VILLAGE OF MORTON GROVE APPEARANCE COMMISSION

April 4, 2022 - 7:00 P.M. AGENDA

CASE AC 22-02

<u>PETITION</u> Request for an Appearance Certificate for site, building, and landscape plans for a 10-unit attached

ALUMINUM TRASH ENCLOSURE SCREENING
DARK GRAY

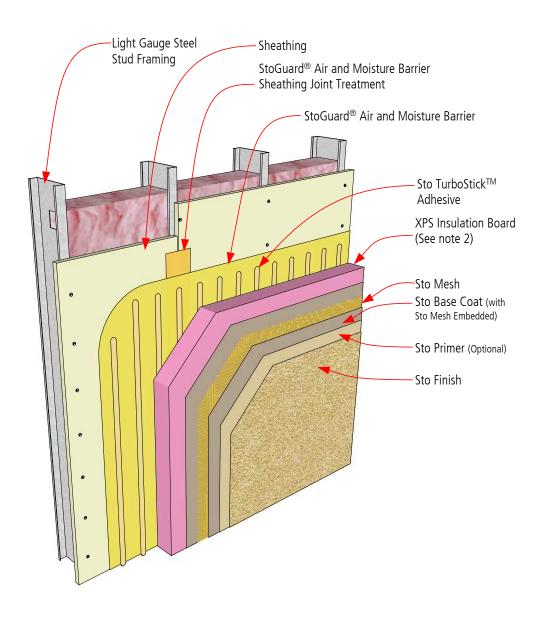
Mr. Thulaseedas asked if a metal screen could be used for the trash enclosure instead of a solid wood fence, which did not fit with the modern development. He referred to the screening detail and added that the installation would look more like art than an enclosure.

Staff notes that the materials palette and the renderings submitted by the applicant show inconsistency in brick coloring. The applicant should verify the proposed coloring of the brick veneer for the Appearance Commission.

- 4) Exterior luminaires on the property may not exceed 4,000K (degrees Kelvin).
- 5) Screening of the trash area shall be designed and installed in accordance with the requirements of Section 12-11-4 and may be made of metal as submitted.
- 6) The exterior wall finishes shall be periodically cleaned and maintained to provide a like-new appearance. Any surface cracks or other damages shall be repaired within 60 days of occurrence, or as otherwise approved by the Building Commissioner.
- 7) Final brick colors to be presented for approval by the Community Development Administrator and Chairperson of the Appearance Commission.

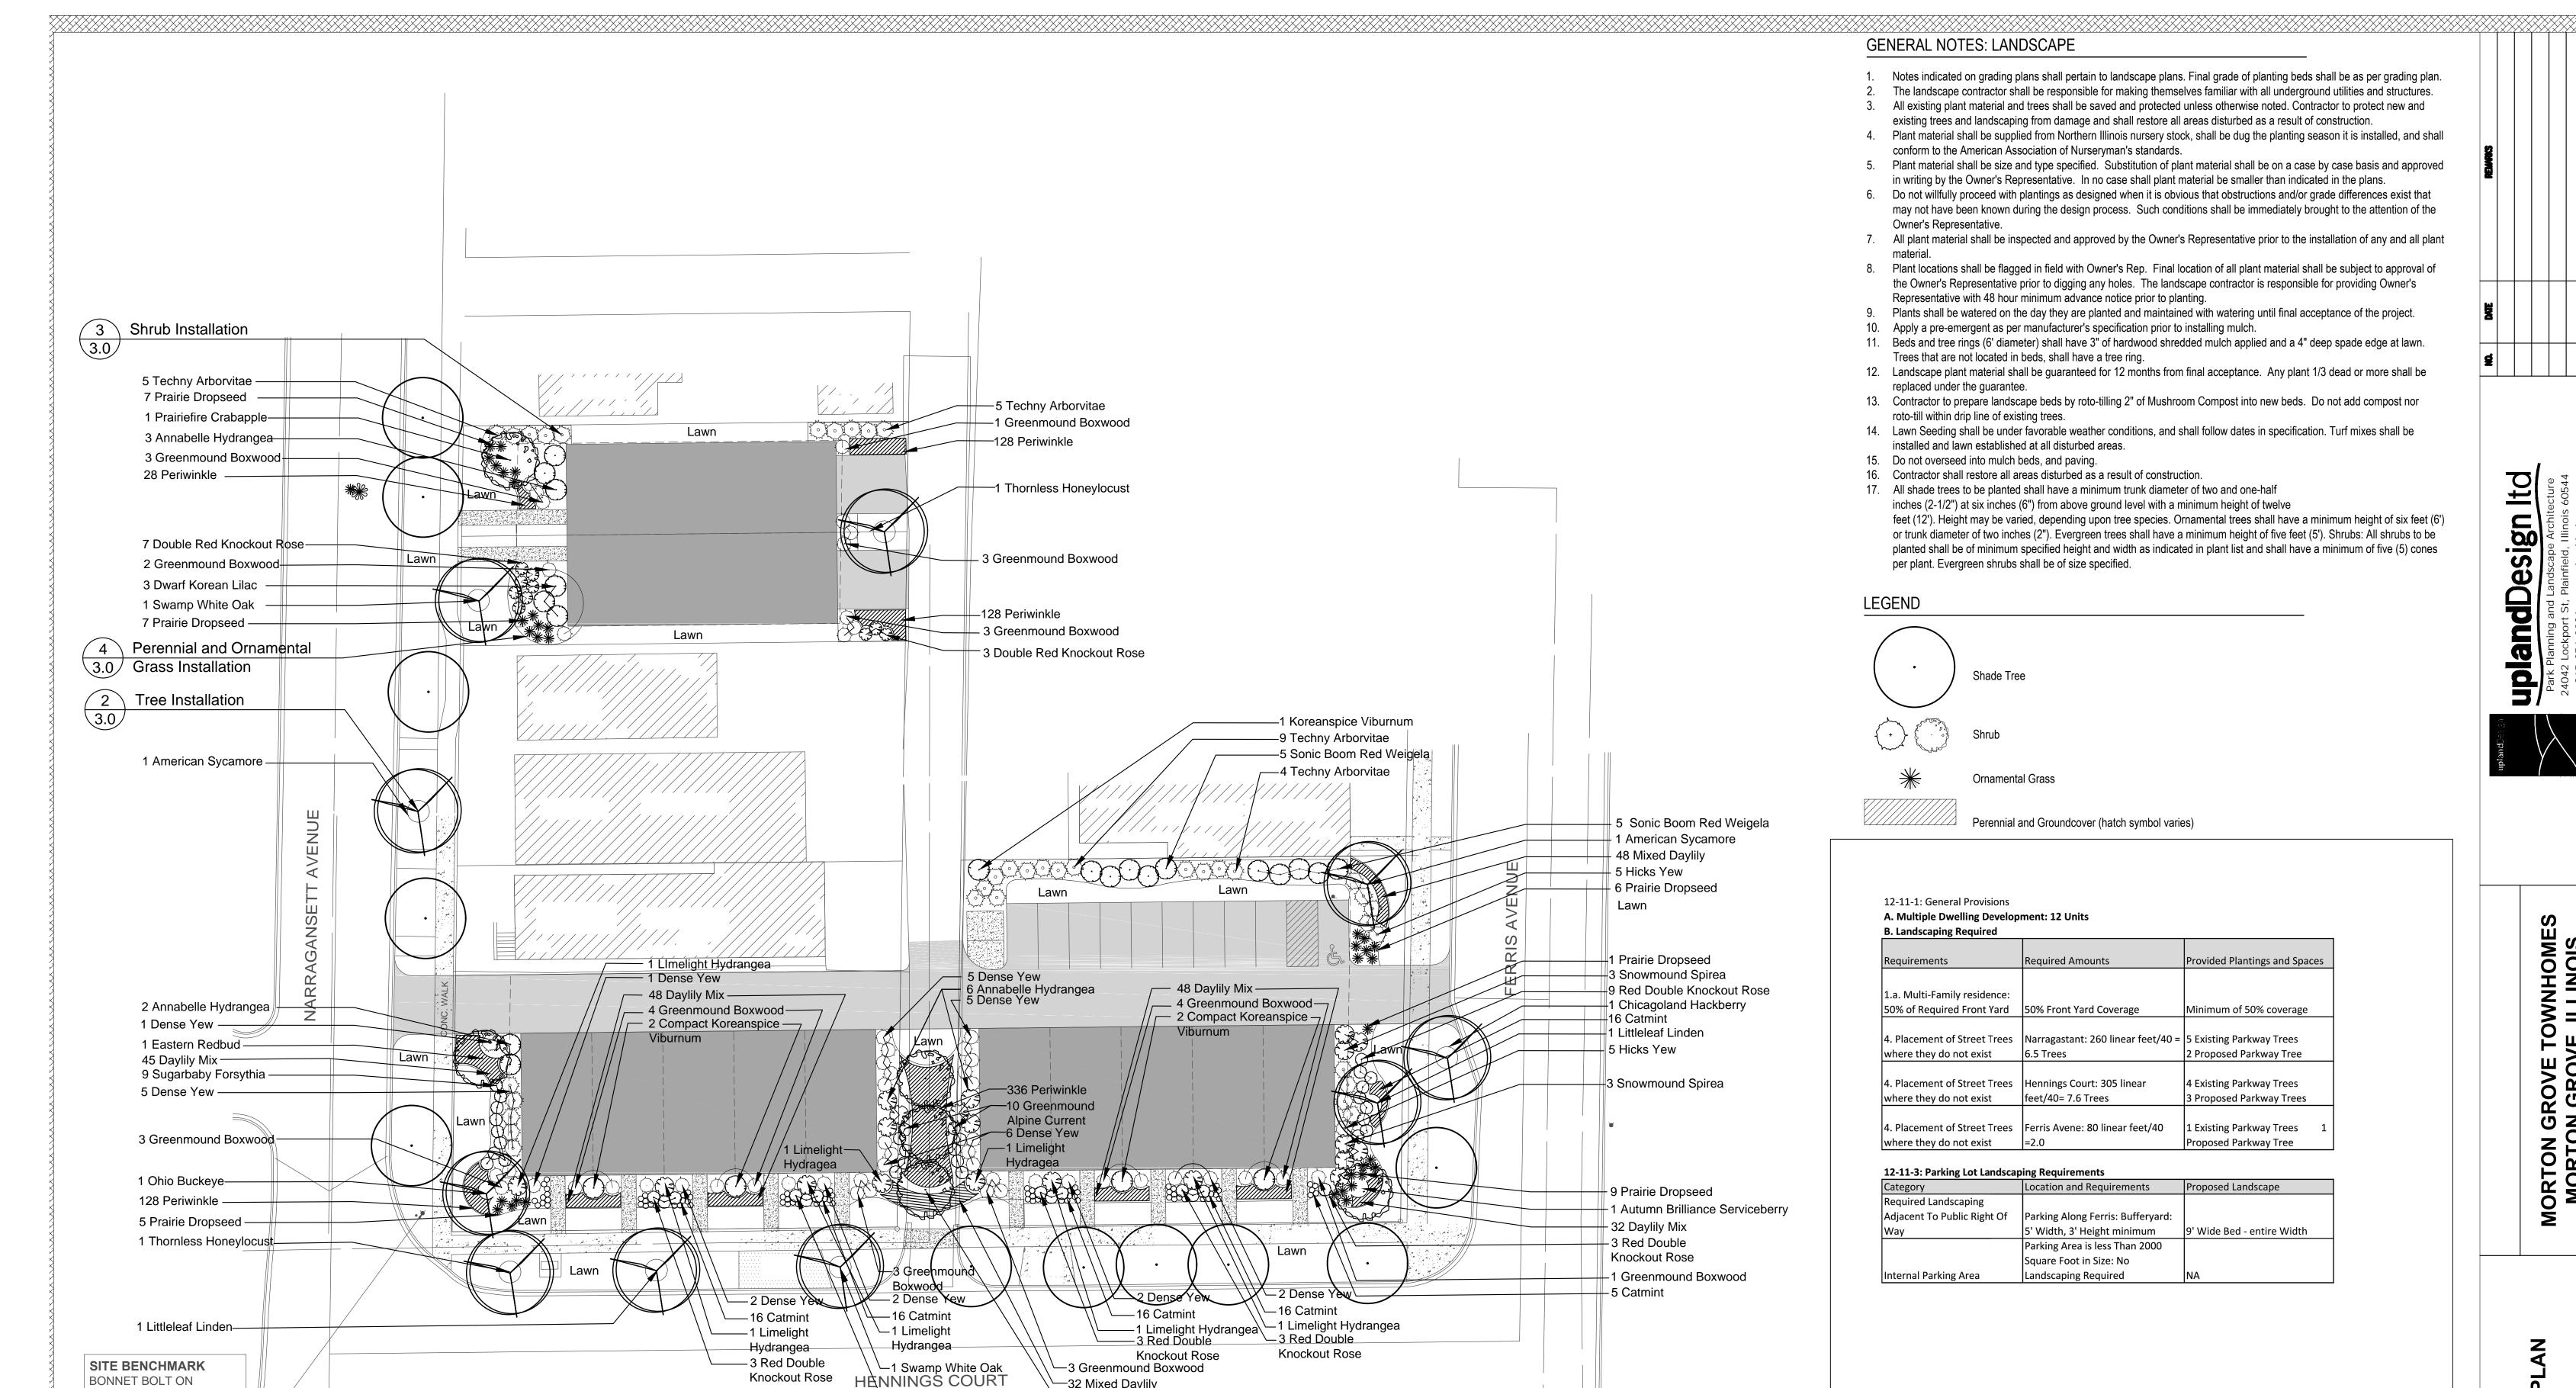
Board member Zimmer noted the lack of upright plantings that would help break up the buildings. He asked if the plantings were limited to low heights so as not to obscure the windows.

Because proposed plantings to the east of the surface parking lot only measure 24 inches per the landscape plan, staff recommends that the applicant verifies that the height of the plantings at maturity will comply with the 3-foot minimum height requirement for parking lots abutting a public right of way. If the plantings will not comply, the applicant should modify the selected species, subject to approval of staff, to comply with the minimum height requirement.

The submitted plans do not indicate that the proposed dumpster area to the west of the surface parking area will be screened in accordance with Village requirements. Per Section 12-11-4, the minimum height of required trash area screening is five feet. Appropriate materials include masonry and solid wood fencing. **The applicant should speak to whether required screening will be provided in accordance with Village Code requirements.** Staff recommends that a variation is not granted and that final screening details are approved by staff.

Mr. Thulaseedas responded that this was the intent, but that he will ask the landscape architect to revise the plan to add more variety in plant height.

- 1) Prior to filing any Building Permit Application, the applicant shall provide the Village with a final landscape plan for review and approval by the Community Development Administrator and Appearance Commission Chairperson. If the landscape plan is deemed to be inconsistent with the approved plan, the applicant will be required to file an application for an amendment to the Appearance Certificate.

PHOTOMETRIC PLAN

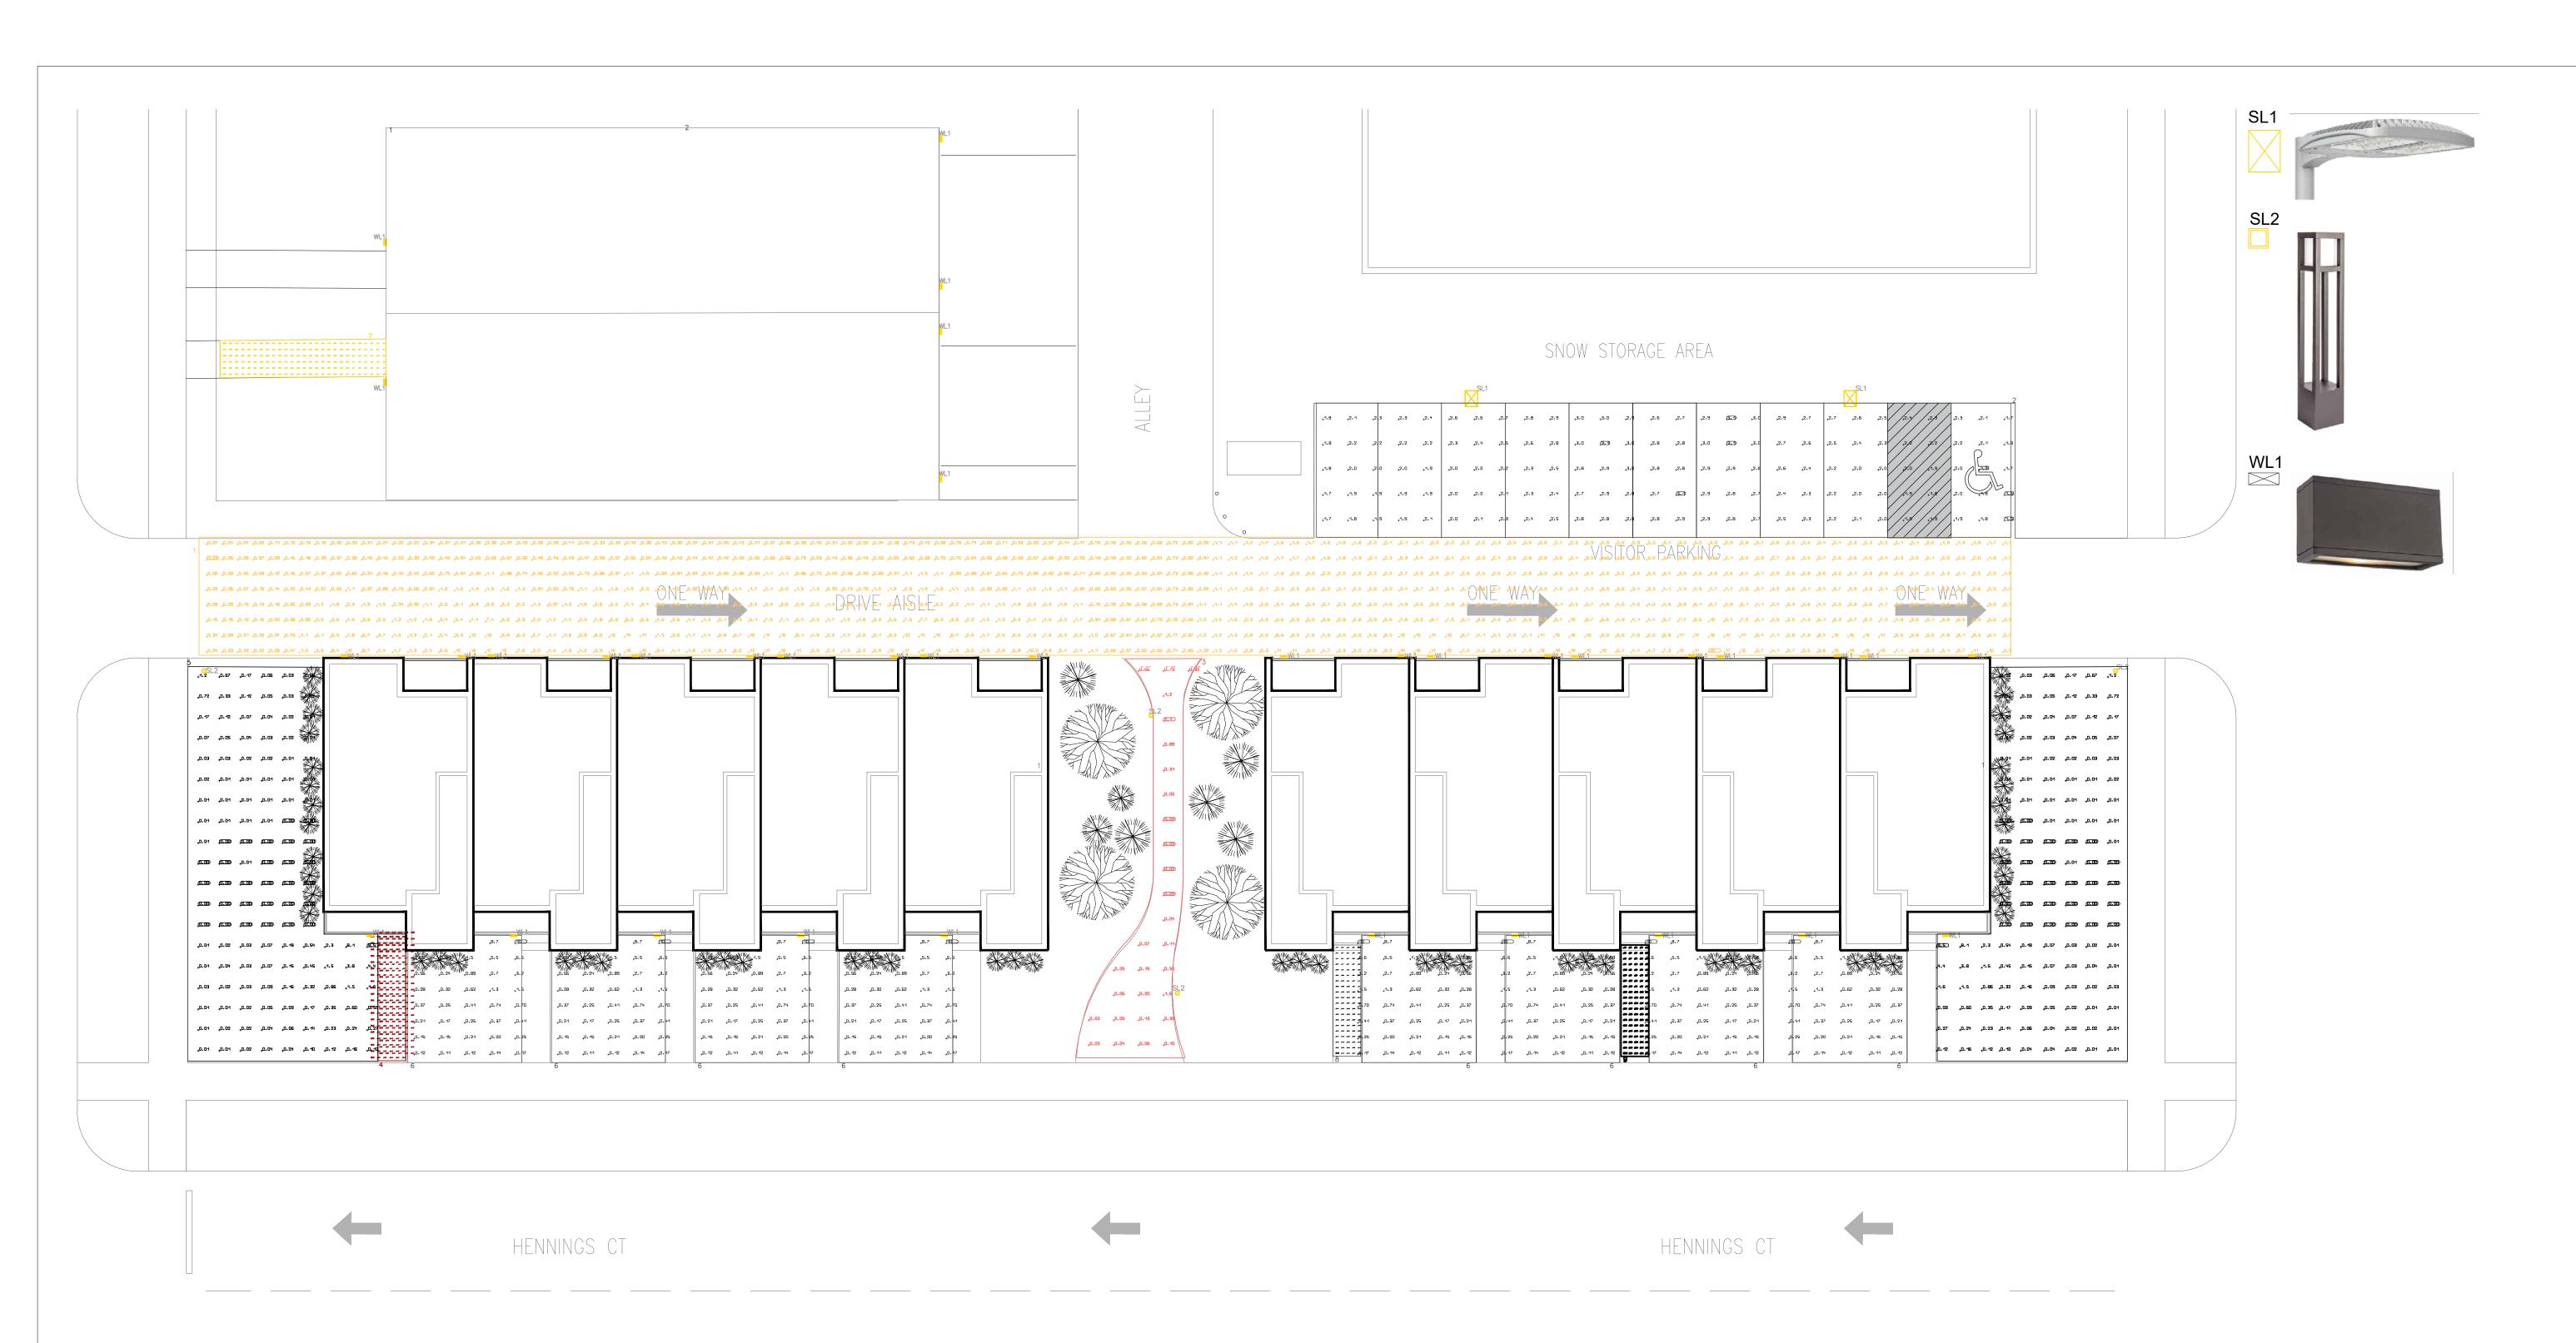
The applicant submitted a photometric plan prepared by KP+J Architects showing levels of illumination along lot lines measuring up to 1.2 foot-candles. Prior to a building permit being issued, the plan should be revised to extend to and beyond all lot lines bounding the development site to verify compliance with Village standards. Levels of illumination are shown to be higher at the rear parking area, which abuts a commercial use, and closer to zero along lot lines farther south of the public access drive, which face residential uses.

Per Section 12-4-3:B.5, lighting of parking and loading areas must be a minimum of one foot-candle on the surface. However, such lighting must be confined to the property boundary and reach as close to zero illumination at the property boundaries as possible. Glare may not be evident from surrounding properties or adjacent public rights of way. The developer will need to modify the lighting plan to achieve as close to zero illumination at the property lines, subject to approval by the Village Engineer.

Section 12-12-3 of the Unified Development Code establishes lighting fixture standards. For off-street parking areas, lighting must be directed away from adjacent property, streets, and other public rights-of-way. All lighting units must be of the full cutoff type, meaning luminaires may not emit any light above the source's horizontal plane. The International Dark-Sky Association (IDA) recommends full cutoff fixtures, which minimize glare and light trespass. The fixtures proposed in the submitted lighting plan qualify as full cutoff fixtures. Staff recommends as a condition of approval that

before any Building Permit Application is filed, the lighting plan must be revised to meet all lighting requirements of the Village of Morton Grove.
